2 October 2020
Our Ref: 20618A.25PS_RTS letter

RE: SSD-9483 UPGRADES TO CHATSWOOD PUBLIC SCHOOL AND CHATSWOOD HIGH SCHOOL

Figure 3 *Perspective of CPS and proposal from Jenkins Street within the context of the desired future character of Chatswood CBD based on strategic and statutory planning controls and approved developments*

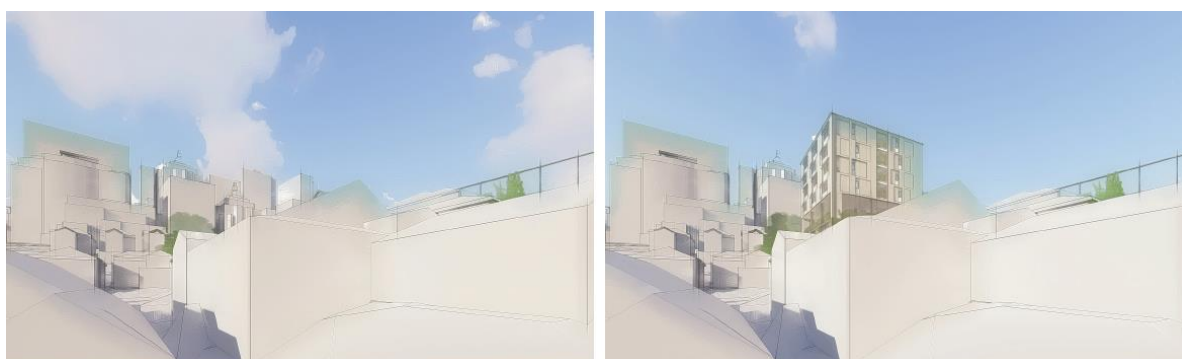
A number of public submissions raised concerns about the height, bulk and scale of Building P1, which is located in the north-western portion of the Chatswood Public School site over the Lower playground area, and within the vicinity of residential dwellings on Jenkins Street and James Street. On 30 July 2020, DPIE raised further concerns in regard to Building P1 and Building G.

Figures 2 and 3 (taken from **Attachment 2**) present a perspective of the desired future character of development in the Chatswood CBD and areas adjacent to the site based on strategic and statutory objectives for development in the area both with and without the proposed built form on the CPS site.

These figures indicate that the visual impact of the built form is consistent with the higher density buildings that already characterise the outlook to the east as well as the potential future development based on strategic objectives and existing statutory development controls. The built form does not 'dominate' the street frontage on Jenkins Street as it is located within the site, away from interface with the public domain. The proposal is consistent with the transitional character of the site having regard to its gateway position between the low-density areas to the

Figure 4 Amendments to Building G floor plan

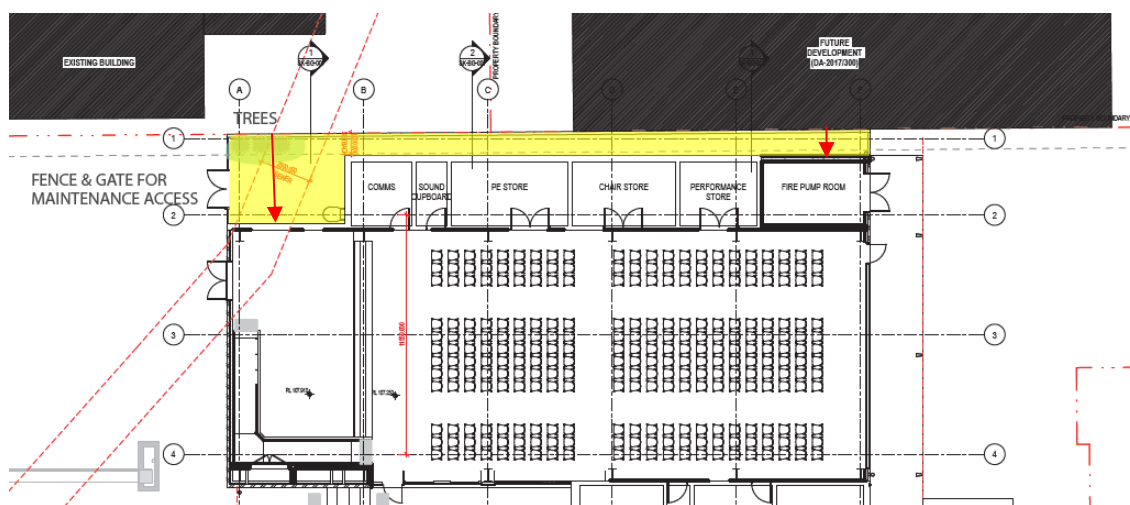
Concern was raised by DPIE in regard to the proposed 0m side setback to the northern boundary, where it adjoins the residential property at 1 James Street particularly in relation to overbearing built form with poor outlook from within the private open space of that property.

In response to DPIE's comments, the design of Building G has been amended as follows:

- Increase setback at the north-west corner of Building G to James Street neighbour;
- Provide overall boundary setback of 1m to the northern boundary;
- Relocated and consolidated bathrooms in the southern part of the plan; and
- Fence and gate added for maintenance.

These changes are shown in yellow in **Figure 4** below and are reflected in the updated Architectural Plans at **Attachment 8** and supported by a Stormwater Engineering Statement at **Attachment 10**.

Table 1 – Summary of Design Review Options

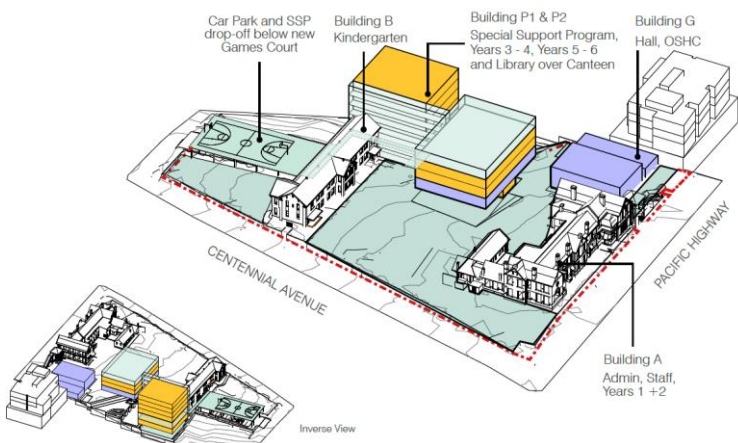
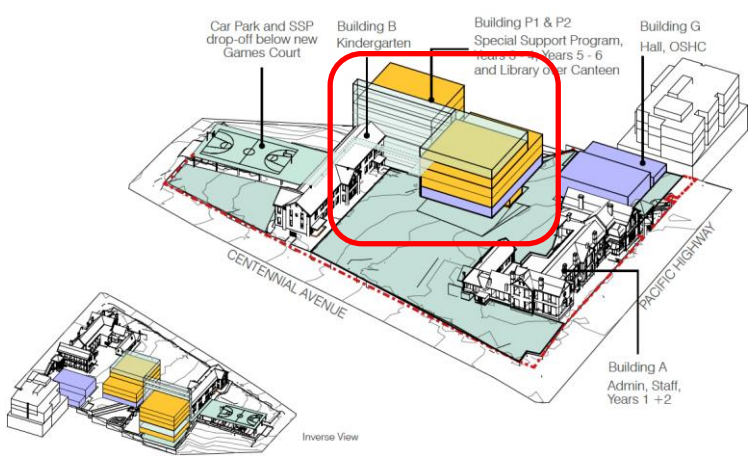
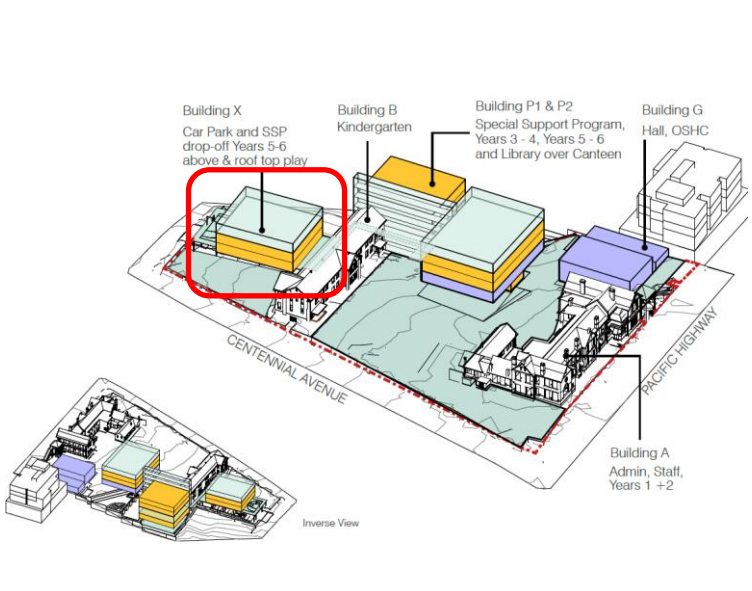
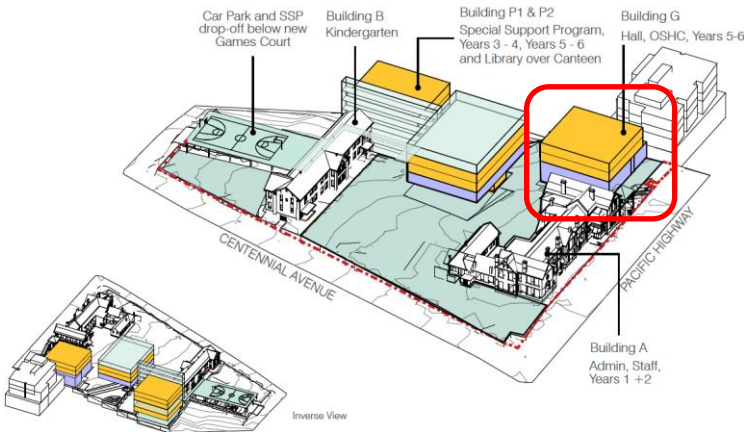
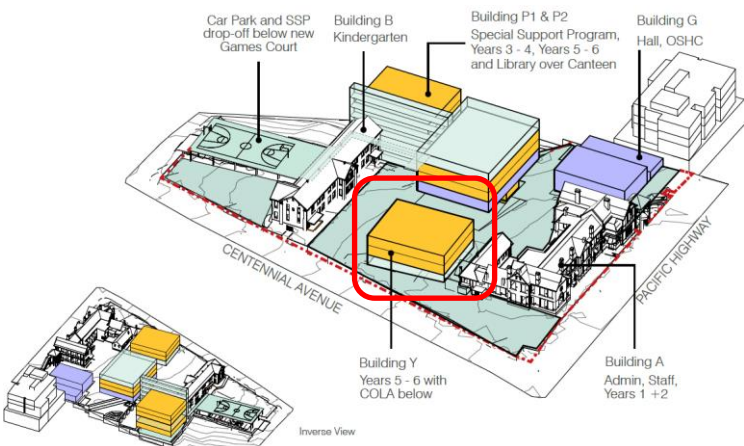
The project team has reviewed the scheme proposed under the SSDA and explored options to adjust the design to distribute height to the centre of the site (i.e. on top of Building P2), or what options are available to relocate the two (2) floors of the building elsewhere on the site.

The primary driver for this was feedback received indicating that the top two floors may be contributing to an appearance of excessive bulk and scale that could be avoided if relocated elsewhere.

Option	Design Review Concept (Change in Red)	Comments
Current		<p>Preferred: Current scheme maximises play space, connects to outdoor spaces from learning neighbourhoods, retains visual connection between Building A and B, maintains streetscape character and is within project program, budget and staging requirements.</p> <p>The built form results in bulk and scale impacts on neighbouring properties at 1 and 3 Jenkins Street.</p>
1		<p>Option 1 disconnects access to roof top play space on P2, reduces the overall play space by removing roof top play space. The relocation of building height to P2 will increase height, bulk and scale impacts on residents at 1 James Street. Moderate level heritage visual impacts on Building A by increasing height adjacent to Building A. Additional costs, significant additional delay, requirement for additional lift to P2 and additional bridge connection for equitable access to roof top.</p>

2A		<p>Option 2A disconnects half of a school stage group from their peers, reduces games courts resulting in less outdoor play space. Students and staff at the new building have to travel further to connect with other classrooms, play areas and staff facilities. The addition of height adjacent to Jenkins Street frontage is not in keeping with the streetscape. The additional built form will exacerbate DPIE's issue about the 'boxed in' feeling for residents. Potential heritage impacts on heritage item across Jenkins Street. Additional costs, significant additional delay, significant impacts on staging of works and construction of car park requires additional core and lifts which affect floor plan efficiency.</p>

Option	Design Review Concept (Change in Red)	Comments
2B		<p>Option 2B disconnects access of roof top play areas, disconnects half a stage group from their peers and teachers from colleagues. Additional storeys atop Building G will diminish the landmark qualities of Building A's streetscape presence. Additional levels will read as secondary to Building A. Potential additional privacy and amenity issues for approved residential building to the north would arise from the western portion of the new building. Cumulative impacts for residents at 1 James Street will be excessive. Additional costs, significant additional delay, and new building would require additional core and lifts that affect planning and efficiency.</p>
2C		<p>Option 2C would disconnect students from their peers, reduce the availability of open outdoor play space, increase the building footprint creating a crowded site, increase supervision burden for all play areas, disconnect early stage and Stage 1 students, and reduce legibility of the site for students. The new building would result in a loss of visual connection between Building A and B, CPTED issues arising from reduced supervision. Potential additional heritage impacts of new built form. Additional costs, significant additional delays, location is highly challenging to build and would affect construction staging and major disruption to ongoing operation of school during build phase.</p>

The outcome of the design options review process was that all options which reduced the height of Building P1 introduced additional negative interface, heritage, educational and program impacts.

Figure 6 Interface section of Building P1 and neighbouring property at 1 Jenkins Street

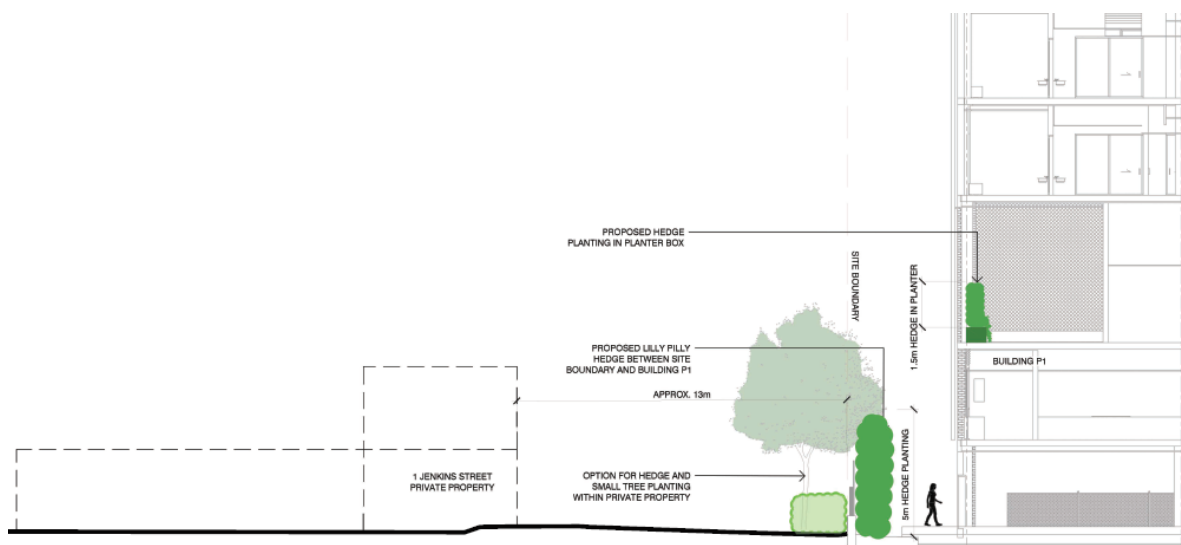
Public submissions raised concern about the height, bulk and scale of building P1, and DPIE raised a range of specific concerns including:

- Amenity impacts of the building on the low scale dwellings at No. 1 and No. 3 Jenkins Street and 2 James Street; and
- Excessive height for this part of the site given wall height, setbacks, shared boundaries, topography of the site and topography of adjoining sites.

Landscaping provided within the COLA and at ground floor will provide additional buffering of view lines and reduce perceived bulk and scale from the built form (**Attachment 12**), including hedge planters at the COLA and additional hedge planting proposed on the lower ground floor level (**Figure 6**).
